Summary of Comments on P:\100\100.064\prelim plan \early grading\100.064early grading cover sheet C0.1 (1)

Summary of Comments on Microsoft Word - 100.064-pdr

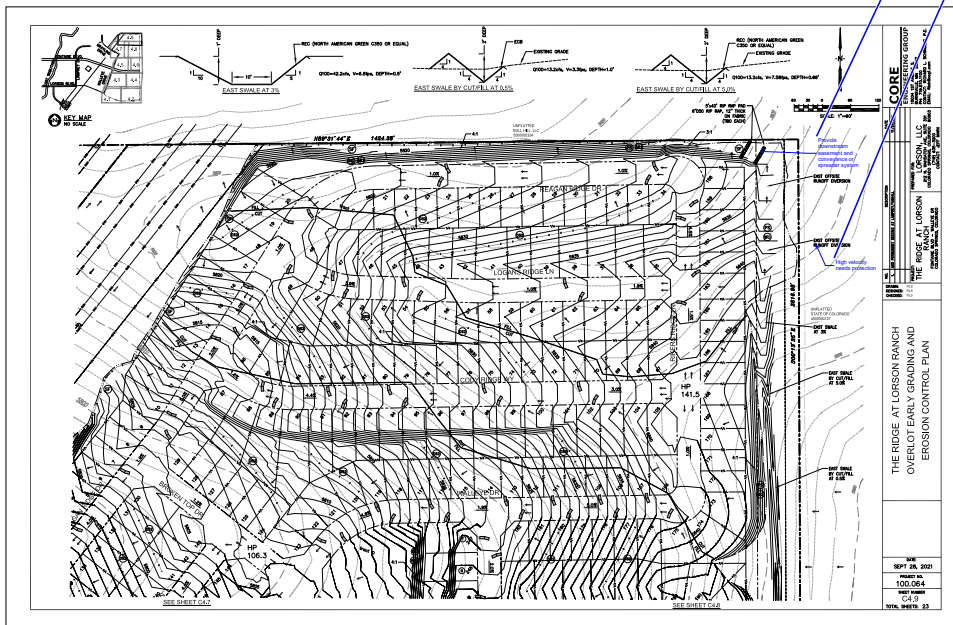
Provide downstream easement and conveyance or spreader system

High velocity needs protection

The downstream conveyance needs to accommodate undetained 100-year flow.

Author: RSchindler Subject: Sticky Note Date: 11/6/2021 8:39:01 AM -05'00'
will secure letter of understanding

Author: RSchindler Subject: Sticky Note Date: 11/6/2021 8:39:16 AM -05'00'
swale changed to 3% which has trm.

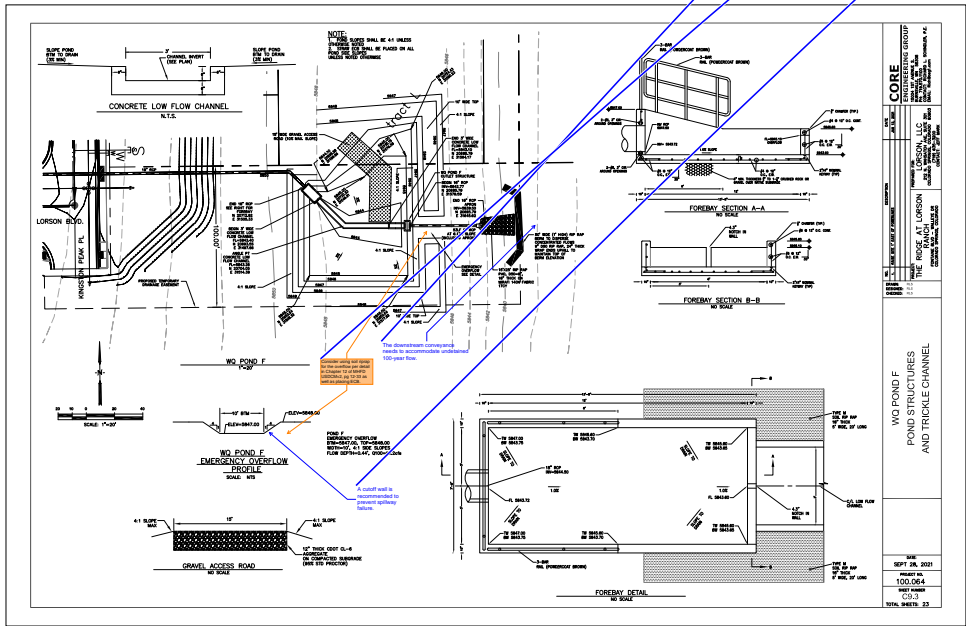
Author: EPC Stormwater - Glenn Reese Subject: Contractor Date: 11/4/2021 1:40:48 PM -05'00'
Consider using soil riprap for the overflow per detail in Chapter 12 of MHFD USDCMv2, pg 12-33 as well as placing ECB.

Author: dsdrice Subject: Callout Date: 11/4/2021 1:35:52 PM -05'00'
A cutoff wall is recommended to prevent spillway failure.

Author: RSchindler Subject: Sticky Note Date: 11/6/2021 8:41:41 AM -05'00'
100-yr undetained (10cfs) flow enters outlet structure. this pond does not detain much beyond WQCV. It all flows into outlet structure.

Author: RSchindler Subject: Sticky Note Date: 11/6/2021 8:39:45 AM -05'00'
added TRM. pond is entirely in cut and overflow is at existing grade.

Author: RSchindler Subject: Sticky Note Date: 11/6/2021 8:40:42 AM -05'00'
added TRM. entire 100year flow enters the outlet structure. pond is entirely in cut so the overflow/slopes are below existing grade and cannot fail.

EAST SWALE 3%

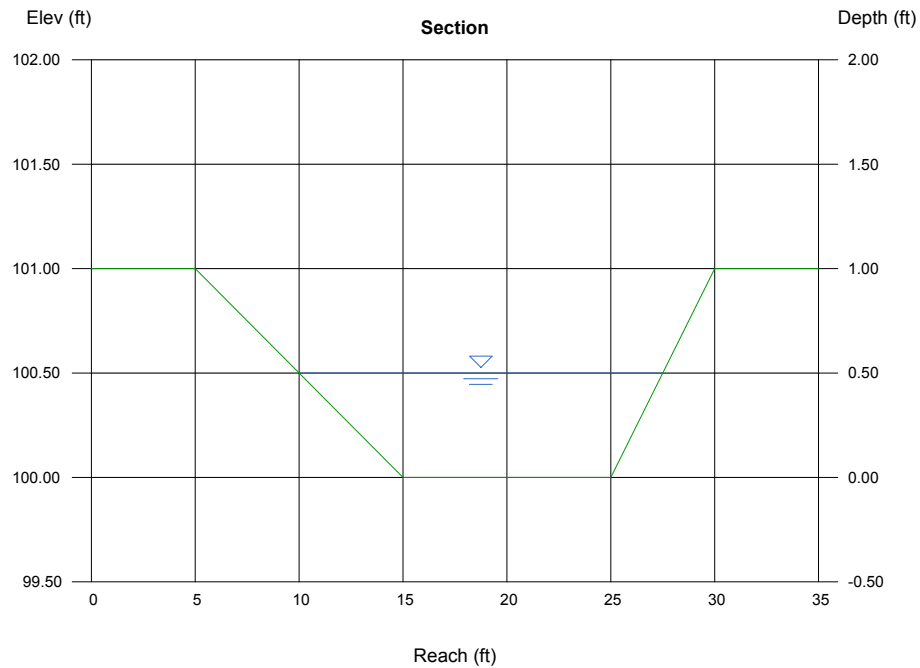
High velocity needs protection

Author: RSchindler Subject: Sticky Note
see grading plan. TRM was added.

EAST SWALE BY CUT/FILL (5.0%)

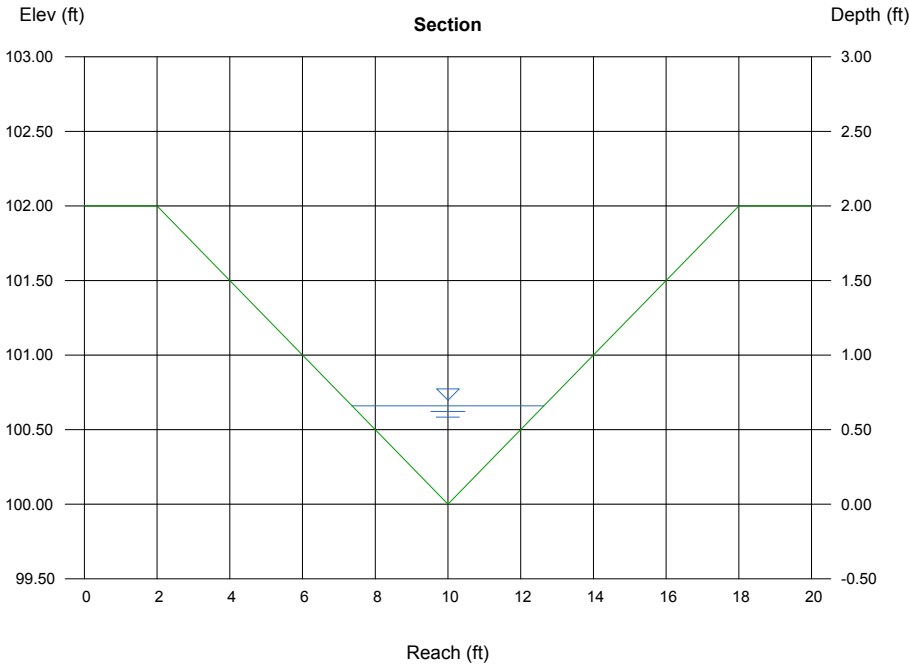
Does this need
lining? What is
shear stress?

-  Author: dsdrice Date: 11/3/2021 5:55:32 PM
7.58
-  Author: dsdrice Subject: Callout Date: 11/3/2021 5:56:10 PM
Does this need lining? What is shear stress?
-  Author: RSchindler Subject: Sticky Note Date: 11/5/2021 11:35:53 AM
yes. we added TRM to that swale.

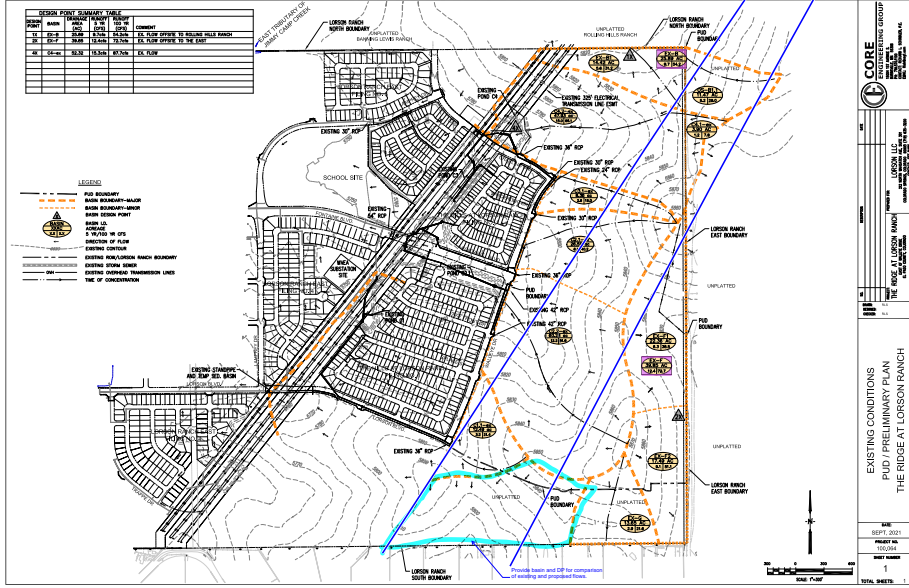
Provide - TRM or
riprap?

Author: RSchindler Subject: Sticky Note Date: 11/5/2021 11:56:28 AM
TRM added
